FILE P.I. # 522460-
STP00-0149-01(030)
Bulloch County
GDOT District 5 - Jesup
SR 67 Improvements

SUBJECT APPROVED REVISED CONCEPT REPORT

**DEPARTMENT OF TRANSPORTATION
STATE OF GEORGIA
REVISED PROJECT CONCEPT REPORT**

Project Type: <u>WIDENING</u>	P.I. Number: <u>522460</u>
GDOT District: <u>JESUP - D5</u>	County: <u>BULLOCH</u>
Federal Route Number: <u>N/A</u>	State Route Number: <u>67</u>

TYPICAL SECTION # 3
157+50 TO 229+50

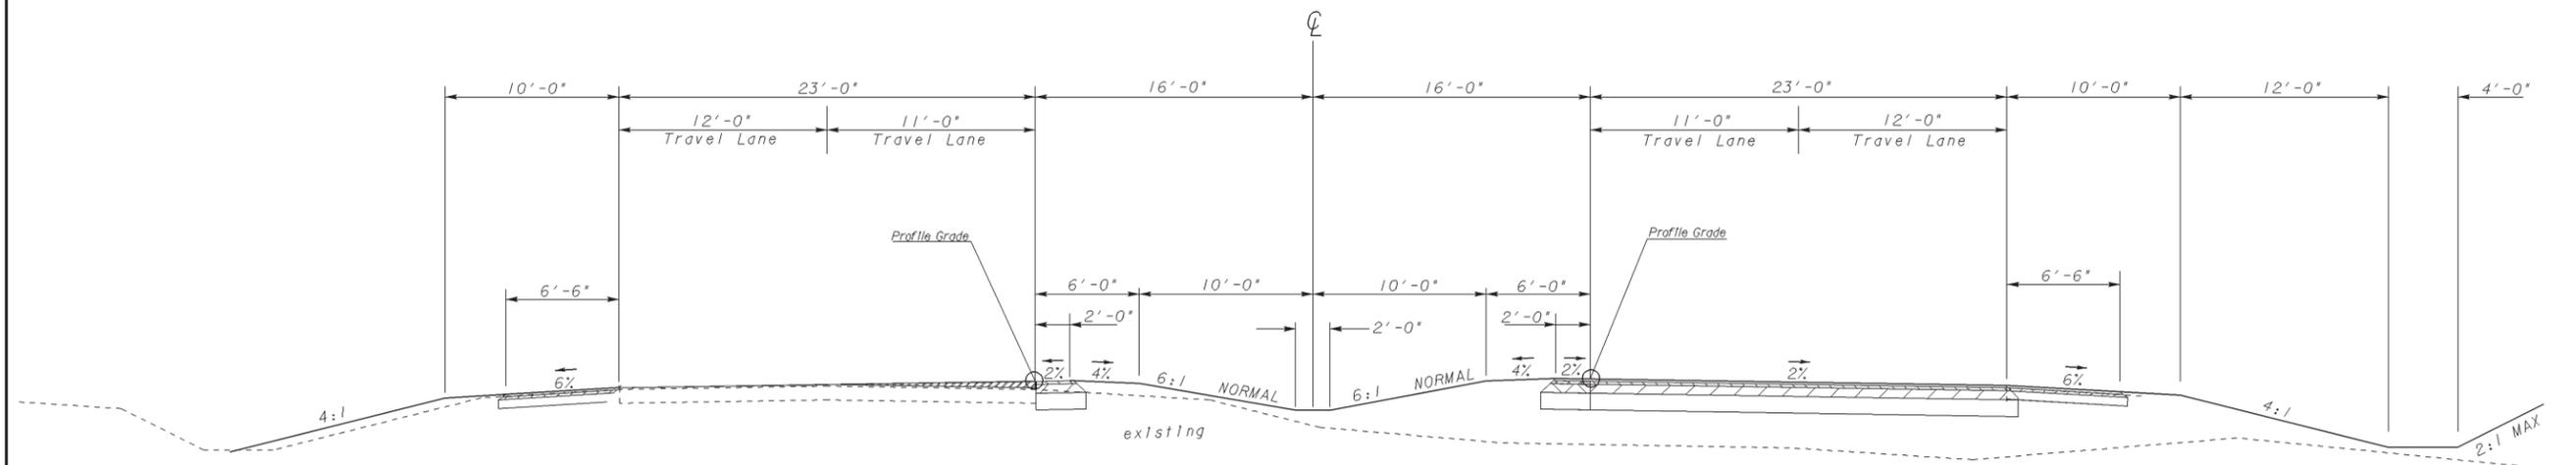
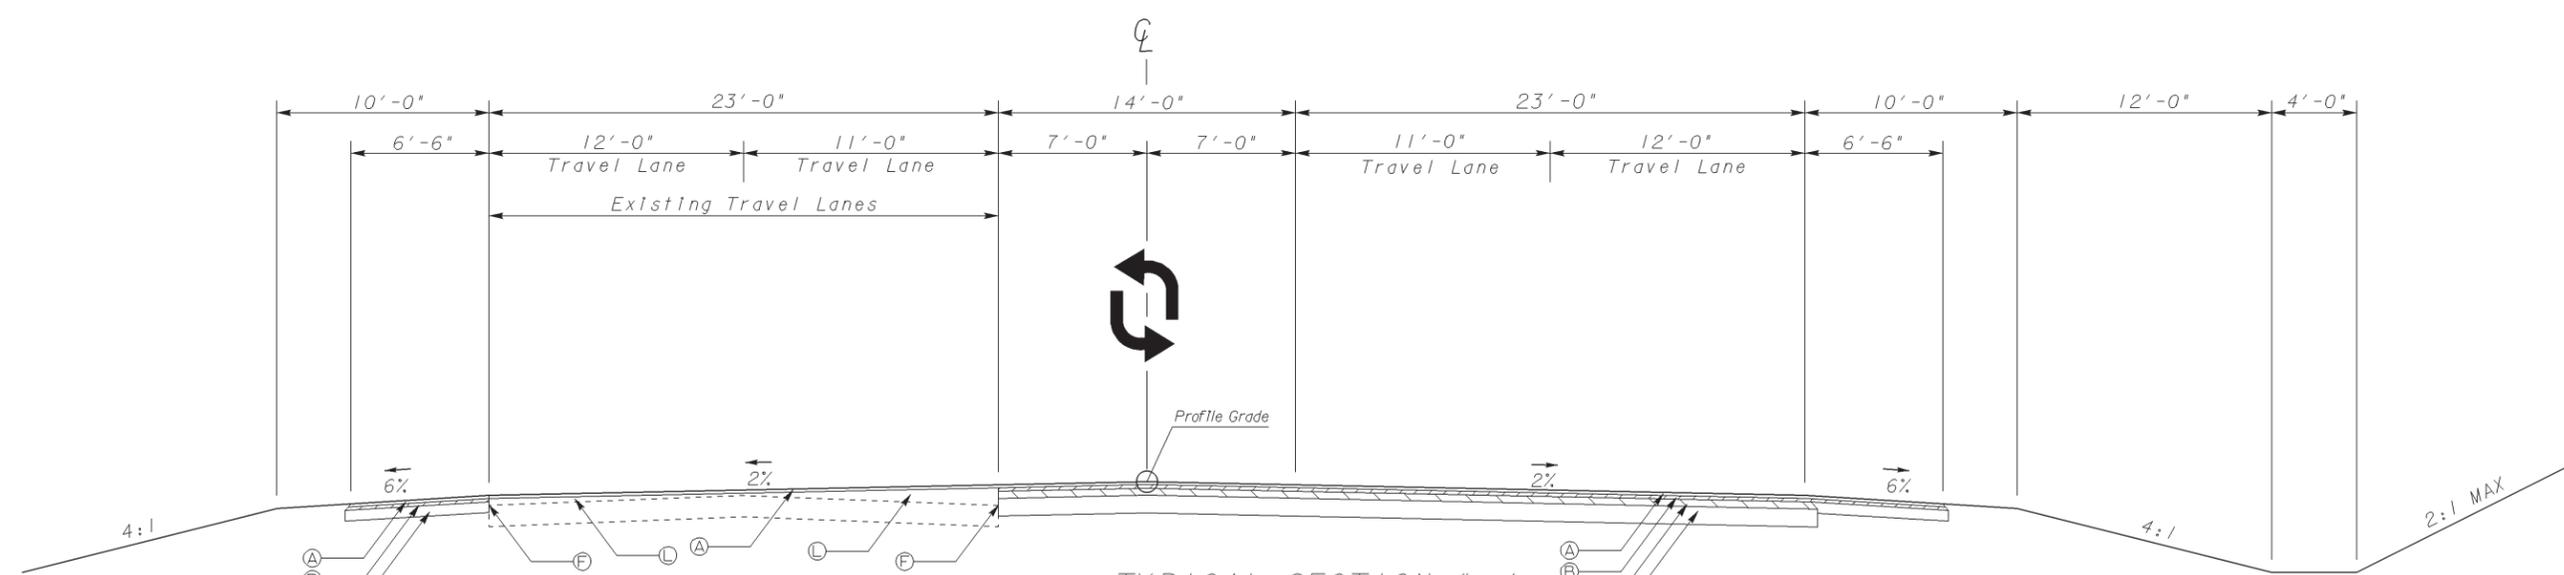
The proposed project revision consists of modifying the median width from 44 ft. to 32 ft., as well as modifying sections of the roadway to a five lane. Also the revision will reduce the inside travel lanes from 12 ft. to 11 ft. This will lessen environmental impacts on Historical Boundaries. The speed limit is being revised to 45 mph in the urban 5 lane sections and 55 mph elsewhere.

Approved Features:	Proposed Features:
<p>The project includes a <u>44 ft. wide depressed median</u>.</p> <p>The approved concept did not address the fact that SR67 is a state bicycle route.</p> <p>The typical sections include <u>4-12 ft. travel lanes</u> throughout the project.</p> <p>The existing 2-lane roadway will be reconstructed to a 4-lane roadway with a 44 ft. divided depressed median (normal), then transition to a 14 ft. two-way left turn lane approximately 200 feet south of CR 585 and continue to the end of the project.</p>	<p>The depressed median will be <u>32 ft. in width</u>.</p> <p>Typical sections will include a 6.5-foot paved shoulder in the rural sections and 4-foot bike lanes will be utilized in the curb and gutter sections of the project.</p> <p>The four travel lanes will consist of <u>12 ft. outside lanes and 11 ft. inside lanes</u>.</p> <p>There will be four 5-lane sections consisting of 12 ft. outside lanes, 11 ft. inside lanes and a 14 ft. flush median:</p> <ul style="list-style-type: none"> • The first 5-lane section is passing through a Historical Site; Resource 4: Martin Miller House, as well as through Denmark community. This section will utilize both rural and urban sections, and the urban portion will require a design speed of 45 mph. Approximately 0.25 mi will have rural shoulders and 0.27 mi will have curb and gutter. (See Typical Section No. 4, 5, and 6) • The second 5-lane section is passing through a Historical Site; Resource 11: Griffin-Futch House. Approximately 3700 ft. (0.7 miles) will have a rural shoulder (see Typical Section No. 2). There will be a 400

<p>Design speed is 55 mph.</p> <p>Construct a parallel bridge over I-16.</p>	<p>ft. section having a curb and gutter section (see Typical Section No. 9). This curb and gutter section will have an 8 ft. paved shoulder, with the curb face 10 ft. from the edge of the travel lane, used to greatly reduce impacts to historical boundaries on both sides of the road and avoid the structure on the right side of the road. Speed design in the 400' portion will be 45 mph.</p> <ul style="list-style-type: none"> • The third 5-lane section is passing through two Historical Sites: Resource 15 and 16: Hagan-Meeks-Bunce House. Approximately 5587 ft. (1.06 miles) will have a rural shoulder (see Typical Section No. 2, 4, 5, and 12). • The fourth 5-lane section is begins approximately 4526 ft. (0.86 miles) south of CR 585 and continues to the end of the project. Approximately 1908 ft. (0.36 miles) will have a rural shoulder (see Typical Section No. 2 and 4) and 420 ft. will have an urban shoulder (see Typical Section No. 6). Speed design will be 45 mph in the 420' ending urban portion of the project. <p>Design speed will be 45 and 55 mph.</p> <p>Parallel Bridge over I-16 is being eliminated.</p>

<p>Reason for change:</p> <p>Reducing the typical section to a 5-lane roadway and a 45 mph design speed in the first three 5-lane project areas will help to reduce the environmental impact on the Historical boundaries and greatly reduce the overall Construction and Right of Way costs for this project. Eliminating the parallel Bridge over I-16 is to reduce overall construction cost.</p>
